# IESO Expedited System Impact Assessment

## INSTALLATION OF LV BUS TIE REACTORS AT MARKHAM MTS#1, MTS#2, MTS#3 & MTS#3E

### 2013-EX692

### FINAL REPORT

**Figure 1 – Typical Reactor Configuration for 2 Transformer Station**

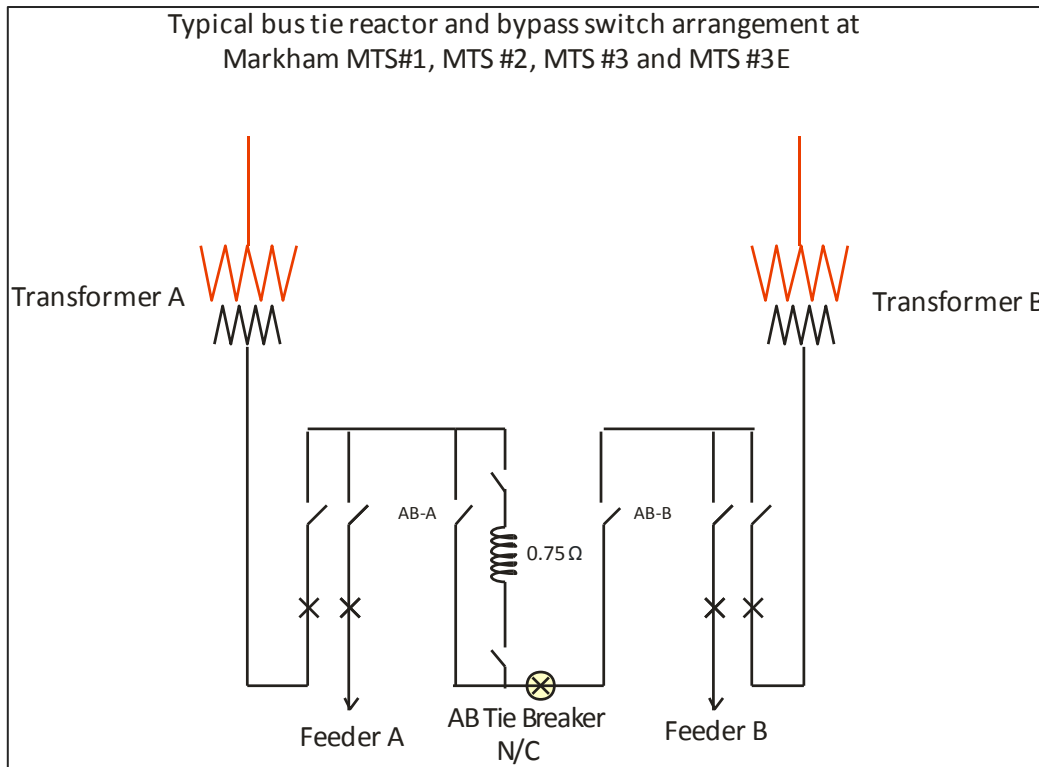
1. The connection applicant must complete the IESO Facility Registration/Market Entry process for the project in a timely manner before the IESO final approval for connection is granted.
2. The voltage drops across the bus tie reactors during a contingency of the loss of a transformer breaker must be taken into account by the LDC.

The switches on either side of the reactors are manually operated. The existing disconnect switch (AB-A in this diagram) on the reactor side of the transformer will operate normally open and will by-pass the reactor in the event of a reactor failure.
